From: Katanic, Janine
Sent: Monday, August 24, 2015 7:18 AM
To: Munoz, Rick
Subject: FW: Chevron Deepwater Projects and Exploration, OCS-G 20082 PS009 ST00BP00 Abandonment

Chevron Deepwater Projects and Exploration

DC3-G 20082 P3009 ST00BP00

Simplified Abandonment Proposal

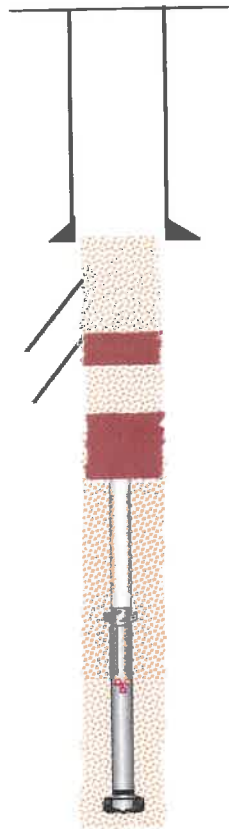
The top source is stuck at approximately 27,092 ft MD and the top of fish (TOF) is not yet established but estimated to be 250 linear feet above the top source @ 26,850 ft MD. Therefore, the irretrievable bottom hole assembly (BHA) will consist of at least 250 linear feet of drill pipe along with other BHA components and will ensure that the sources are not accessible to future drilling operations. The rig will attempt to set a cement plug of at least 200 linear ft above the top of fish. This will seal and isolate the sources in place. A second cement plug may then be set further up the hole, and the rig will drill through this plug to side track the well.

~ 250 linear feet of irretrievable drill pipe left in hole above BHA will ensure that source is not accessible to subsequent drilling operations

Based on the information provided in your proposed abandonment procedures, and the telephone call that I participated on the HOO Bridge, you are hereby authorized to proceed with the proposed abandonment. Should additional complications arrive, please contact the NRC HOO with any modifications to the proposed procedures and the will patch me into the telephonic decision making bridge.
